Addendum #1

Tender #26051 – New Dain City (South Welland) Elementary School

Issue date: May 6, 2026

ADDENDA

DRAWING TITLE:
Site Grading

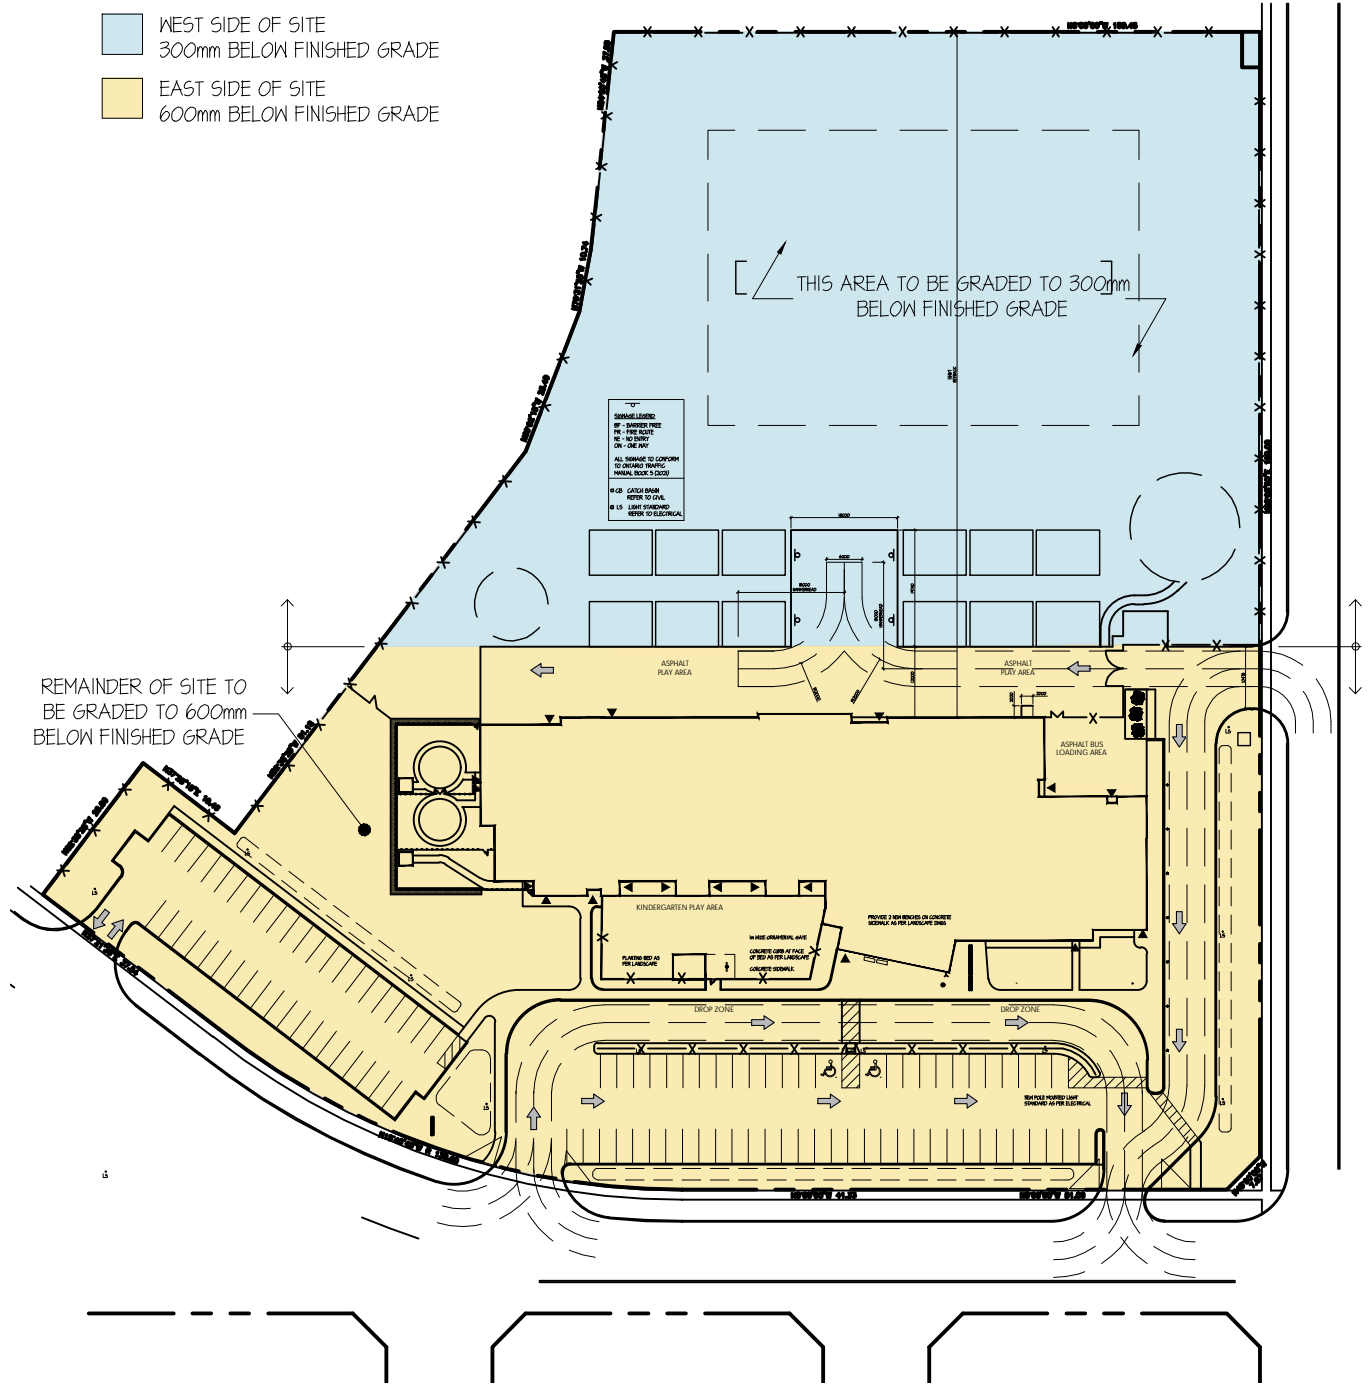
- b. Refer to attached updated finished grade site plan.
2. Refer to drawing A2-0 O.B.C. Plans,
 - a. Revise note CN-6 to read as follows,
3.5.3.3. - FIRE SEPARATIONS FOR ELEVATOR MACHINE ROOMS:

- WEST SIDE OF SITE
300mm BELOW FINISHED GRADE
- EAST SIDE OF SITE
600mm BELOW FINISHED GRADE

- A4. Refer to revised finished grading site plan attached. The site will be compacted (to structural SPD) and filled to grades as per attached overall site grading plan. All compaction results from geotechnical consultants that have been on site during this work will be provided to successful contractor.**

Revised
Sleep 110-15 &
Change 110-16
Layout

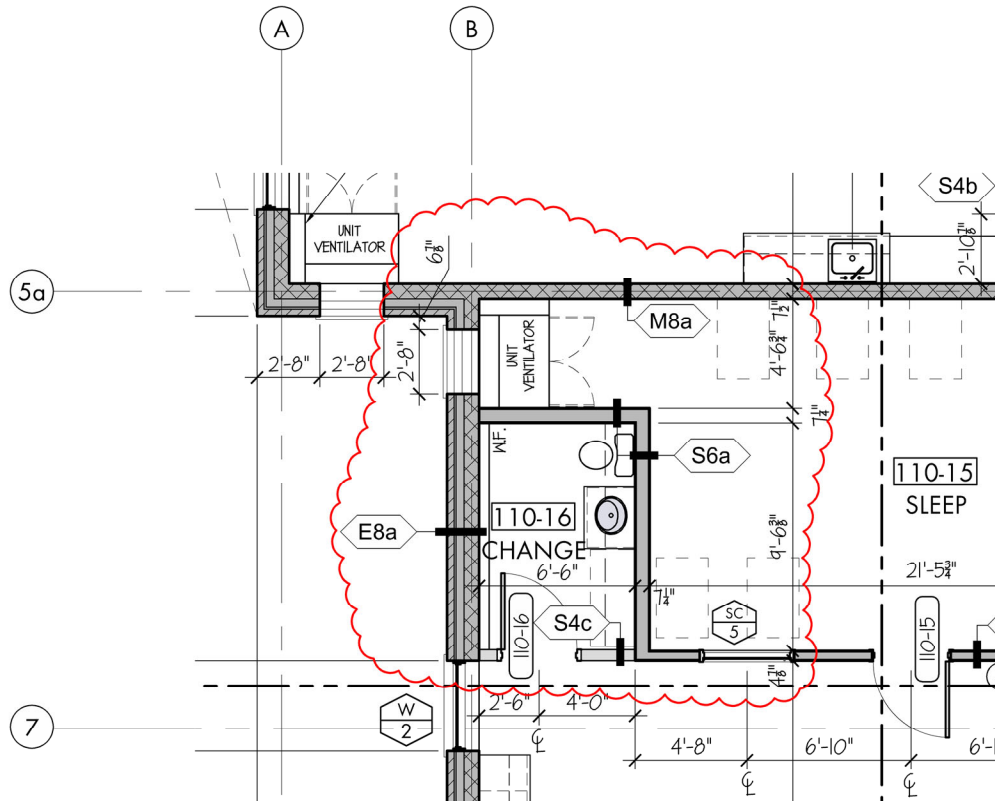
- a. Revise Sleep 110-15 and Change 110-16 layout as shown on the attached sketch SK1.
 - b. Revise Vestibules 105-3, 106-3, 107-3, 108-3, 109-3 layouts as shown on attached sketch SK2.

Revised Interior
Elevation No. 14:
105-3, 106-3,
107-3, 108-3
& 109-3

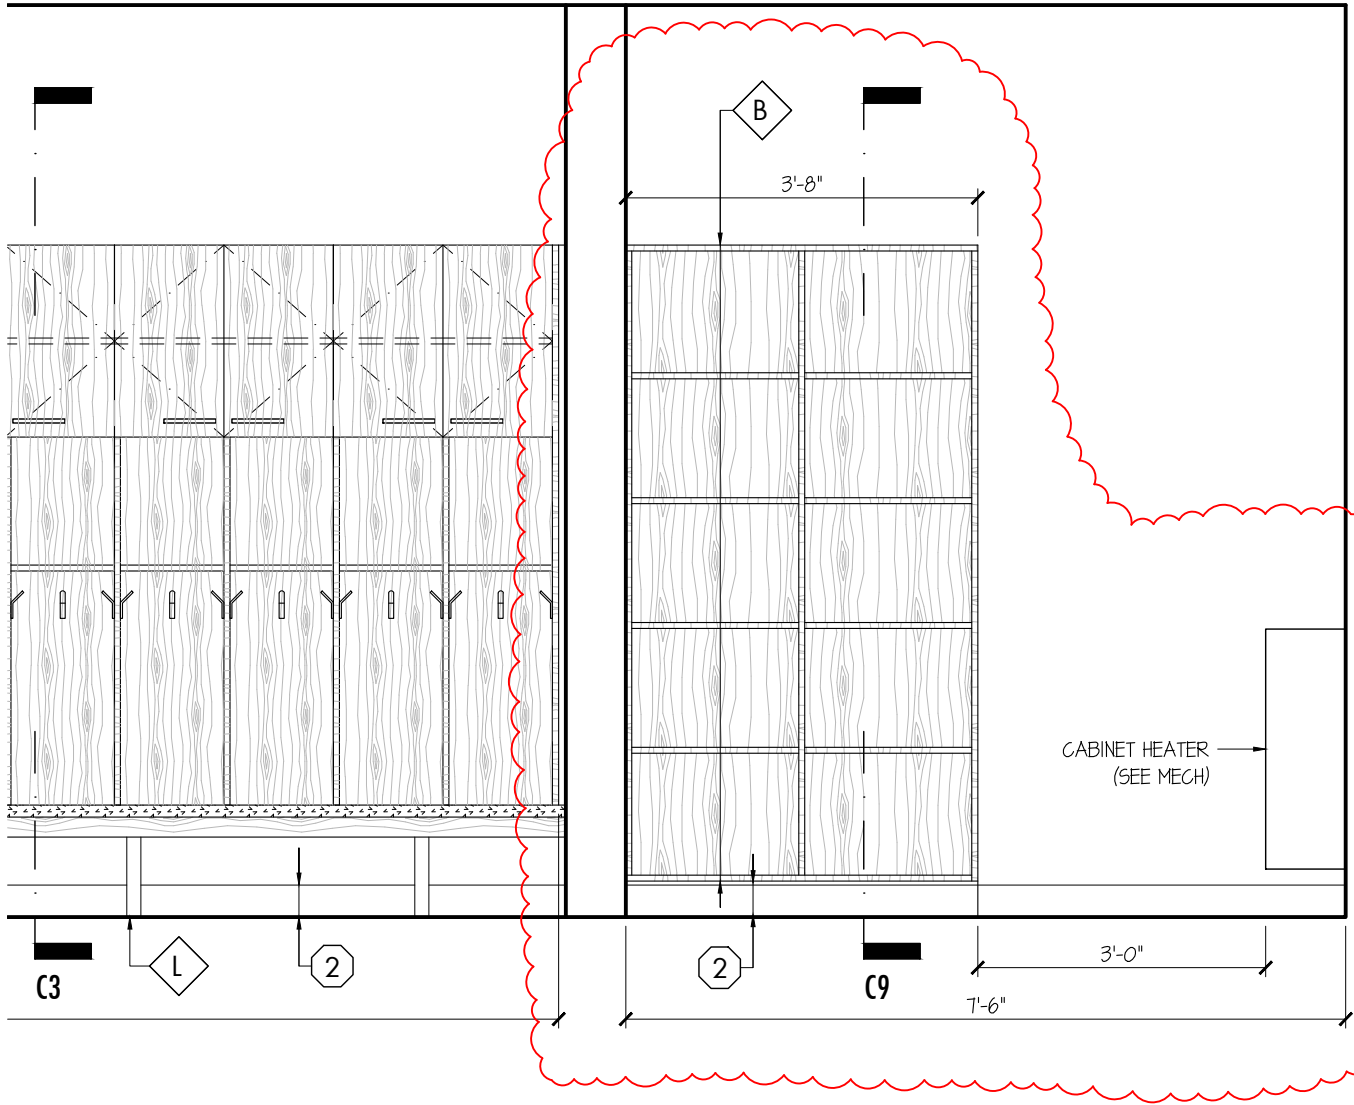
4. Refer to drawing A8-4 Kindergarten & Daycare Interior Elevations,
 - a. Revise Interior Elevation: Typical Kindergarten (Cubby Wall) tagged 14 as shown on attached sketch SK3.

Revised Interior
Elevation No. 22:
Change 110-16

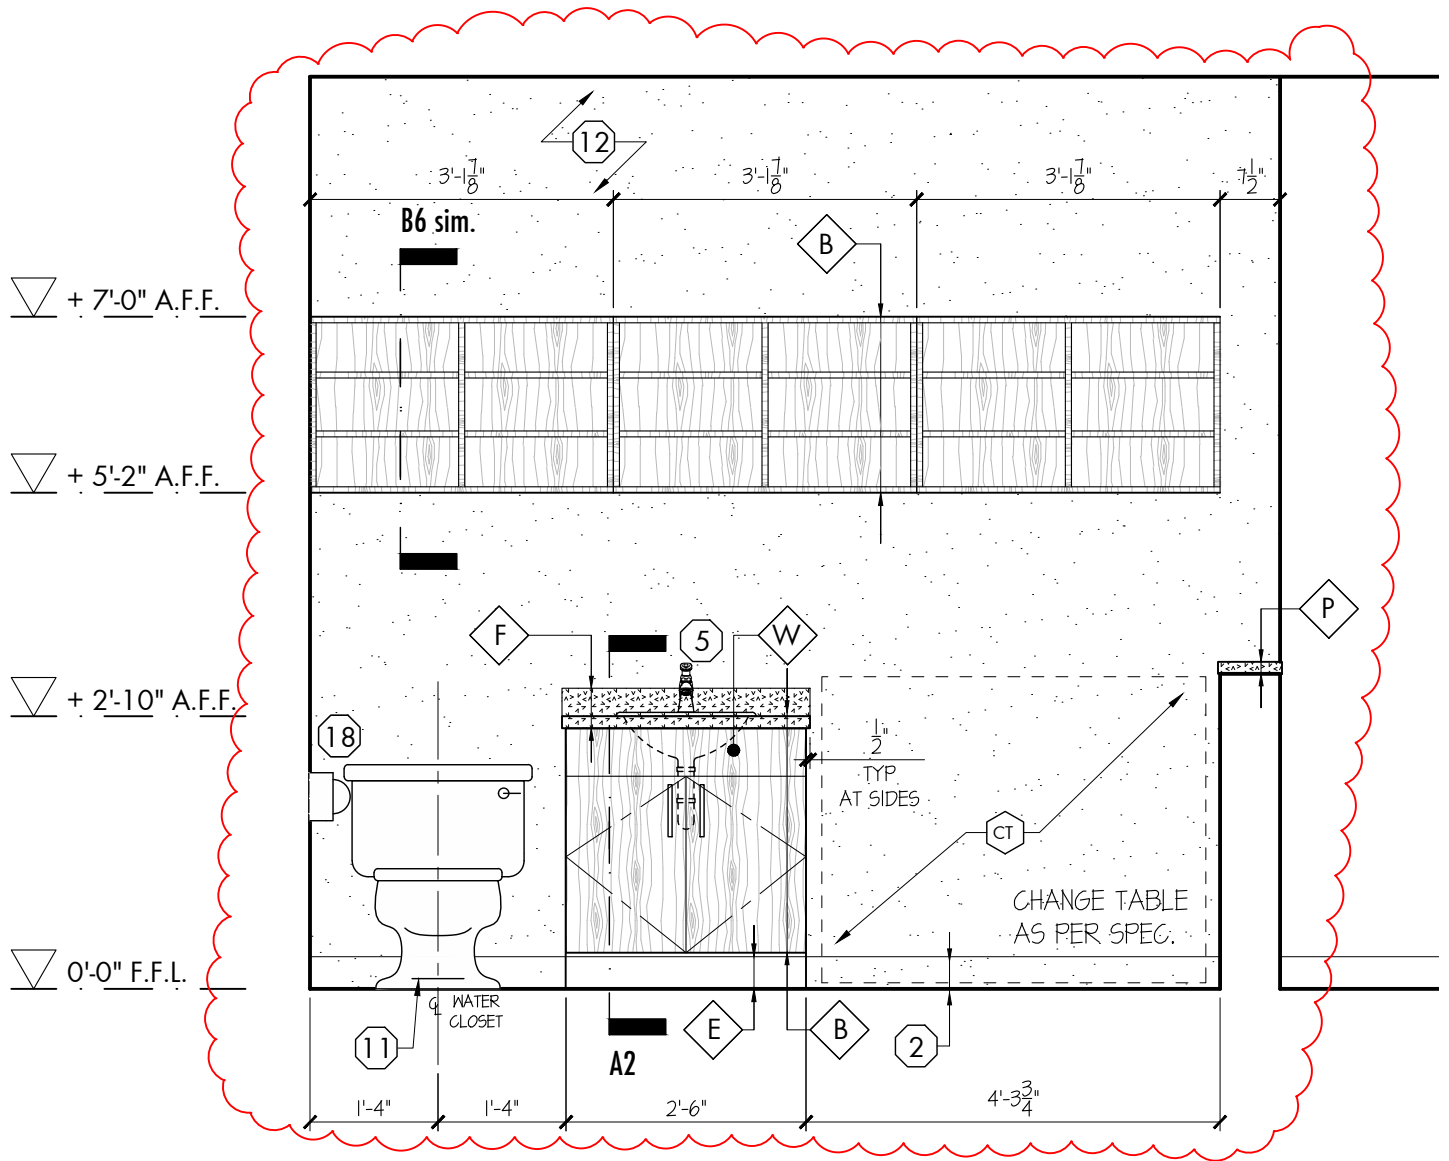
5. Refer to drawing A8-5 Daycare Interior Elevations,
 - a. Revise Interior Elevation: Change 110-16 tagged 22 as shown on attached sketch SK4.
6. Refer to drawing A8-8 Washroom Interior Elevations,
